ADDENDUM 04 – MADISON ES – 2 STORY CR BLDG **PBK**

Addendum No: 03
Project: Madison Elementary School – 2 Story Classroom Building
School District: Madera Unified School District
Prepared By: PBK Architects, Inc.
7790 N Palm Avenue
Fresno, California 93711
PBK Project No: 230278
DSA App No: 02-122191

Issue Date: 01/15/2025
To Drawings + Specifications dated 12/06/2024

CS4.1

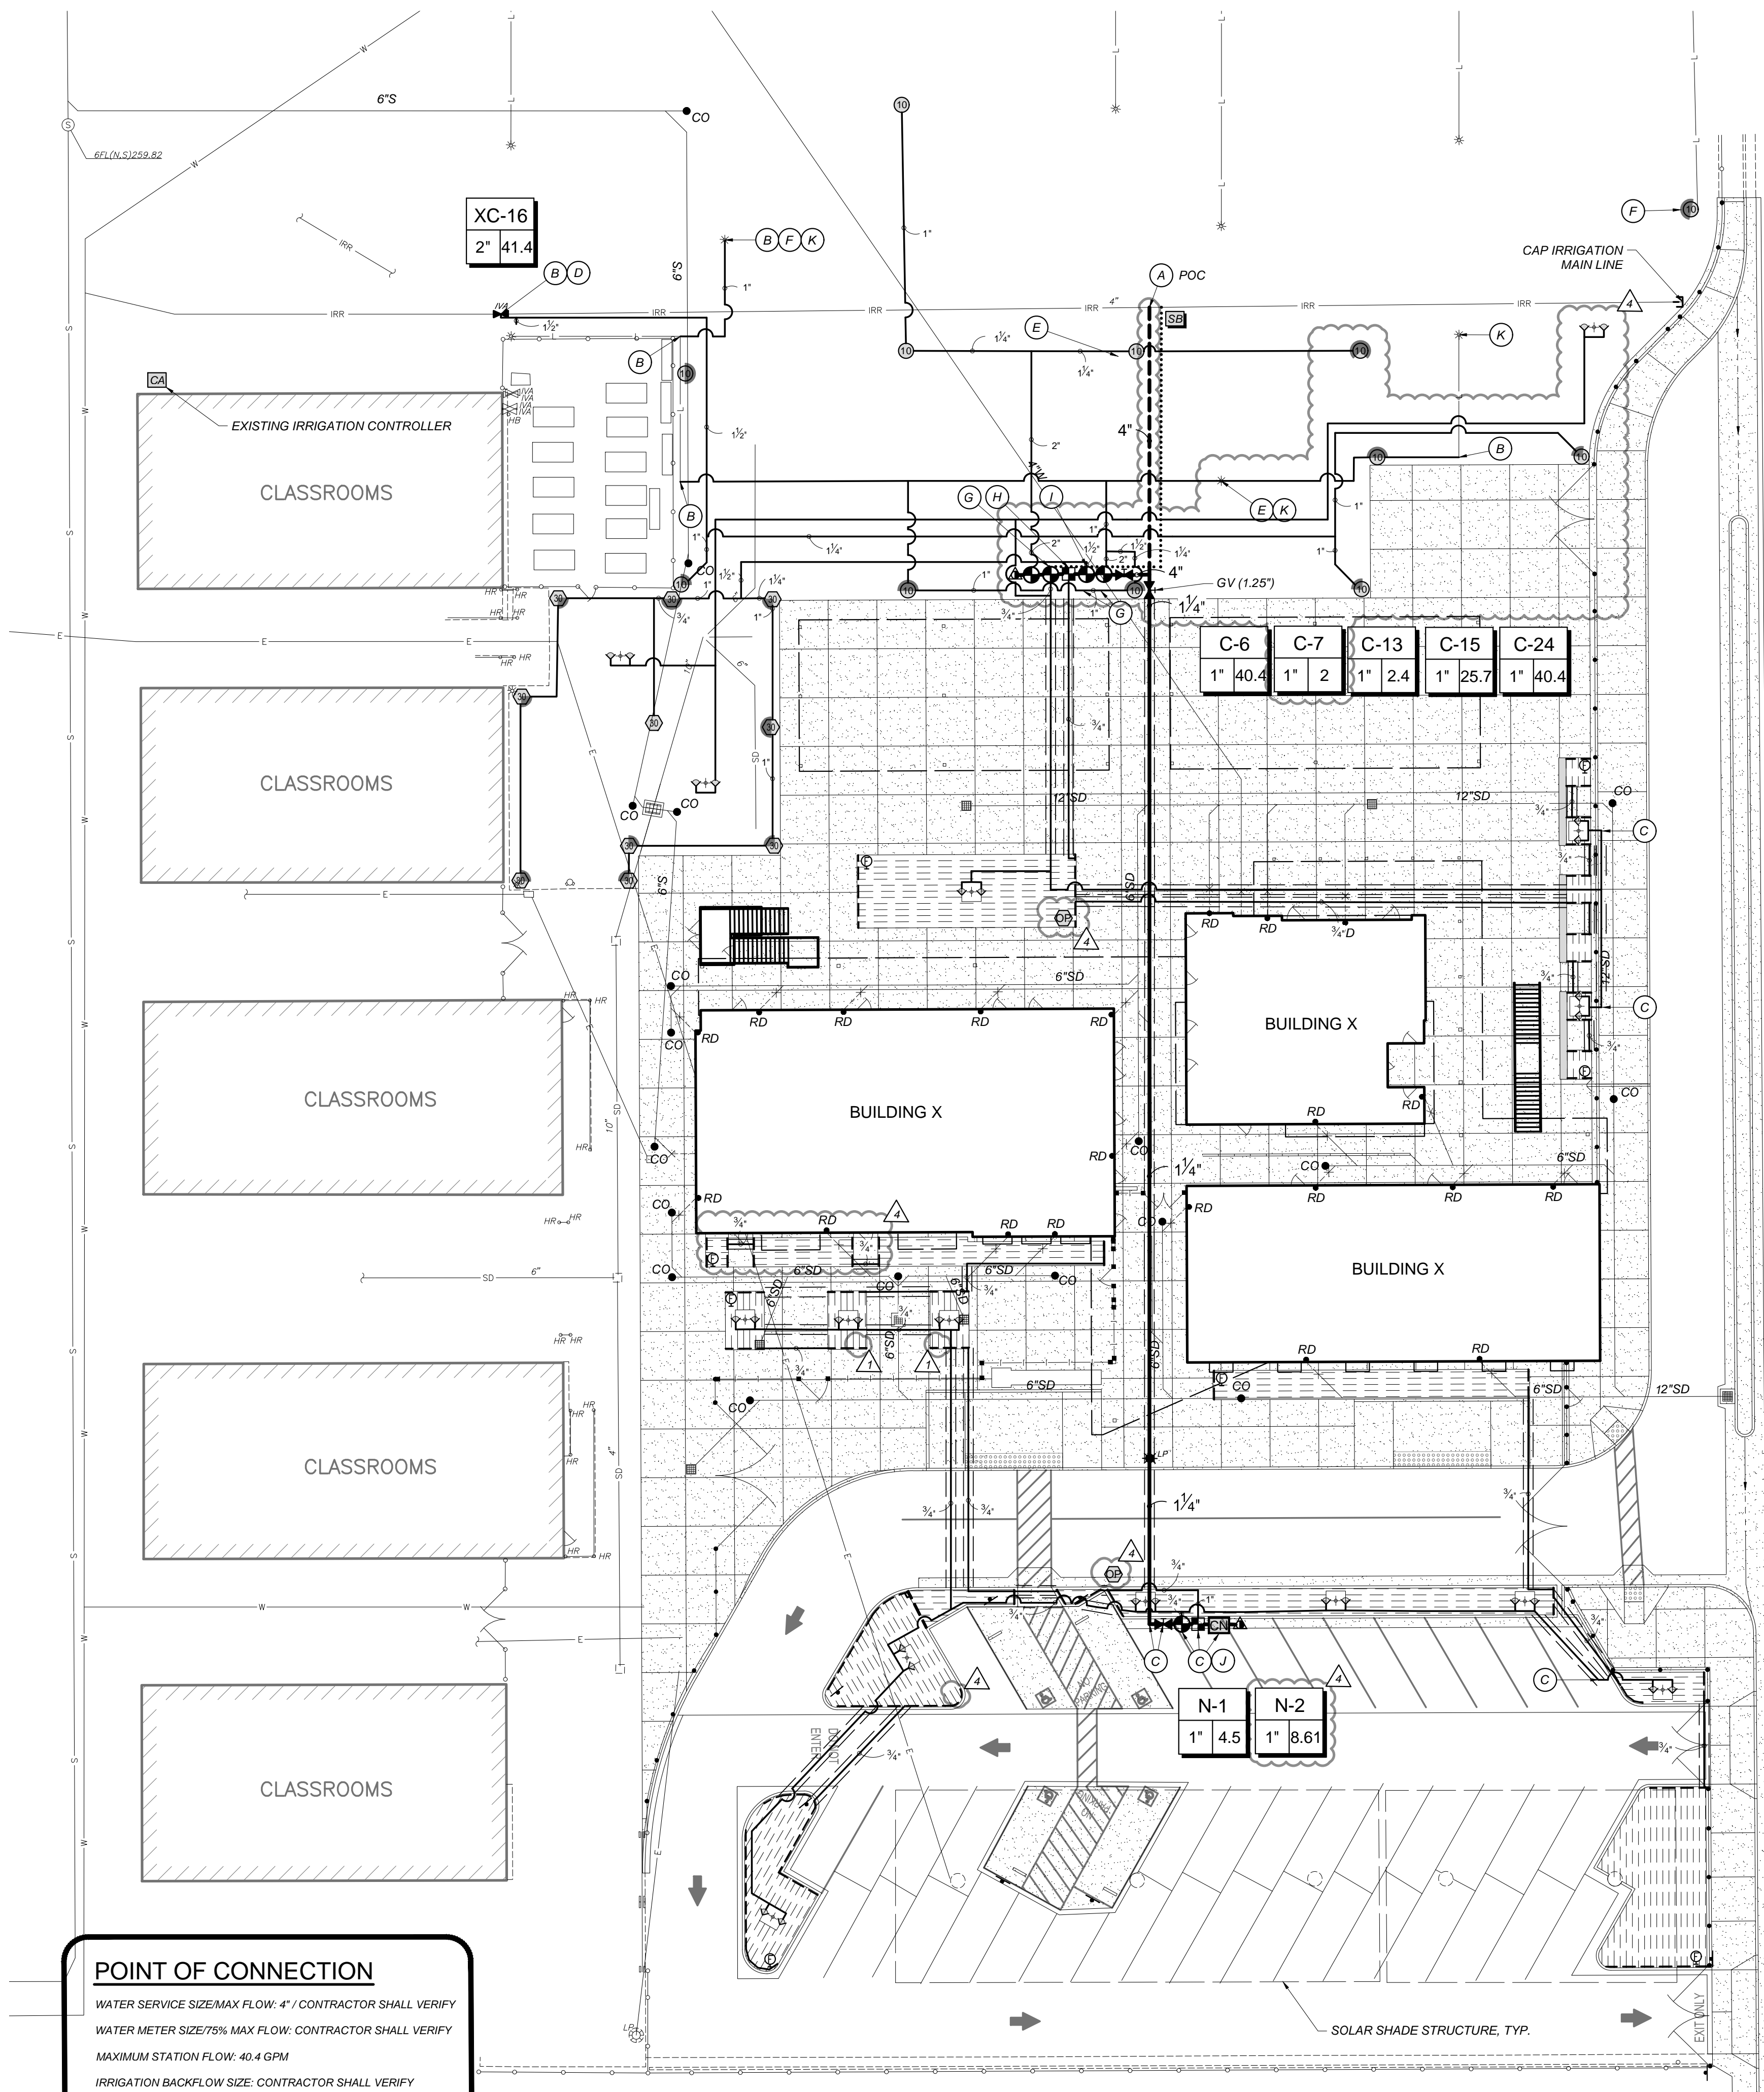
4.14 Refer to Sheet **CS4.1 – Horizontal Control Plan**, revise as follows:

- Added control points for walks on the south side of the west Building X. on project.
- Added control points for heavy duty concrete fire access pad.
- Revised median along Santa Cruz Street.
- Replace sheet with attached CS4.1 – Horizontal Control Plan (1 pages)

IRRIGATION
PLAN
LS1.1

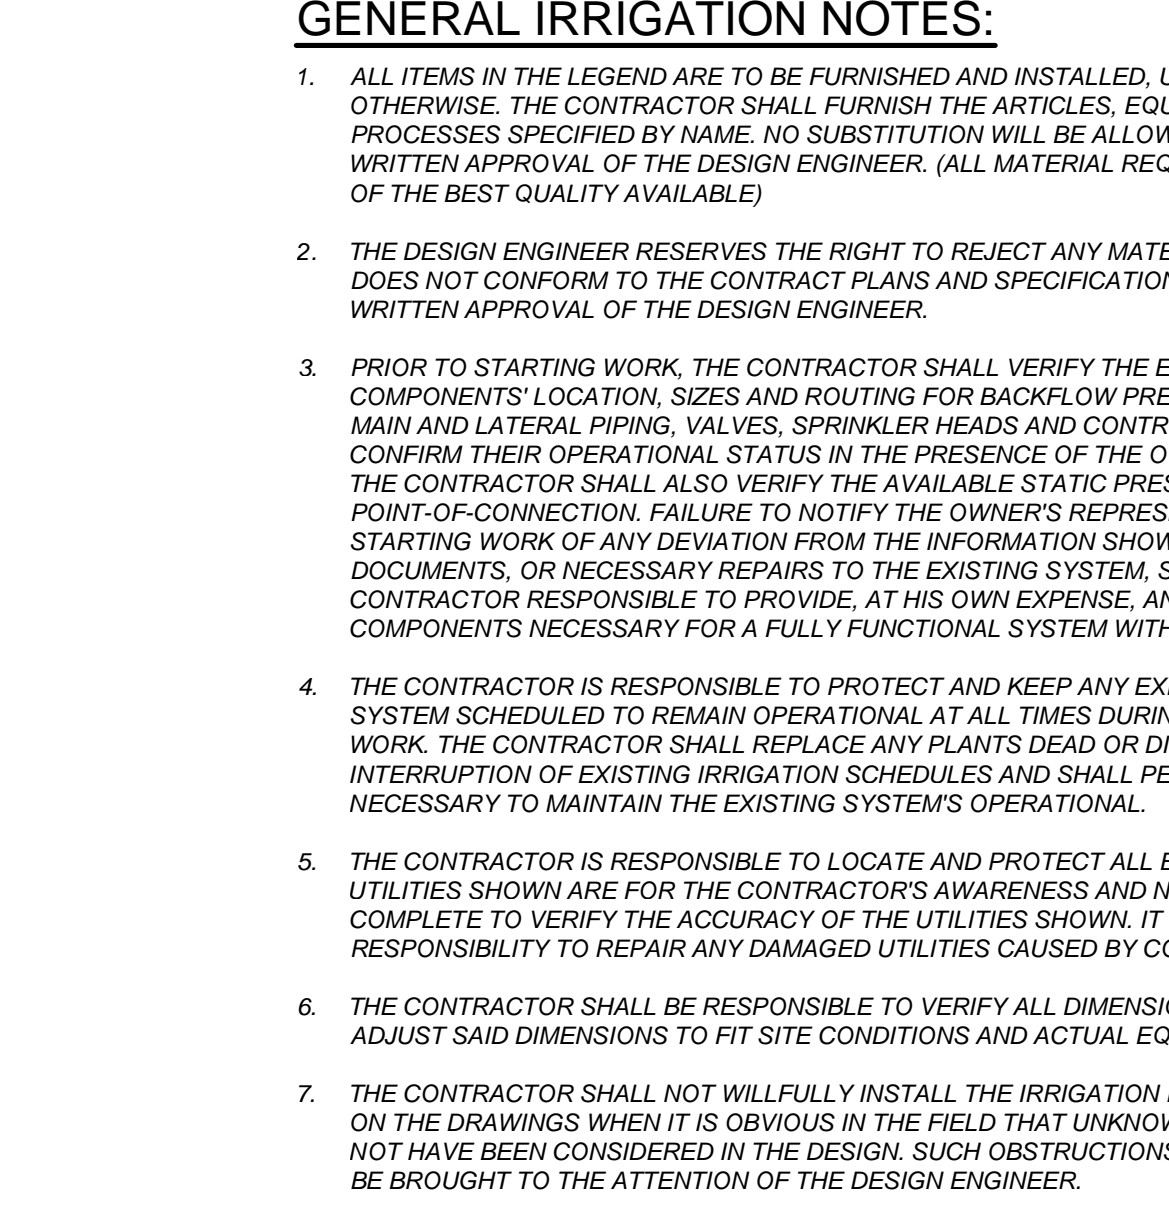
4.16 Refer to Sheet **LS1.1 – Irrigation Plan**, revise as follows:

- Tree bubbler and turf rotor location was revised due to concrete improvements to the northeast of project area.
- GPM for Valve C-7 was revised.
- Proposed 4" irrigation mainline type was revise to PVC Class 200 SDR 21, gasketed pipe.
- Drip operation indicator was added for valve C-13 and N-2.
- Drip area in planter was revised along south side of west building due to site updates.
- Two (2) drip flush valves in tree planter were removed south of west building.
- One (1) drip flush valve was removed in parking lot planter to the west.
- Drip operation indicator was added to legend.
- Replace sheet with attached LS1.1 – Irrigation Plan (1 pages)
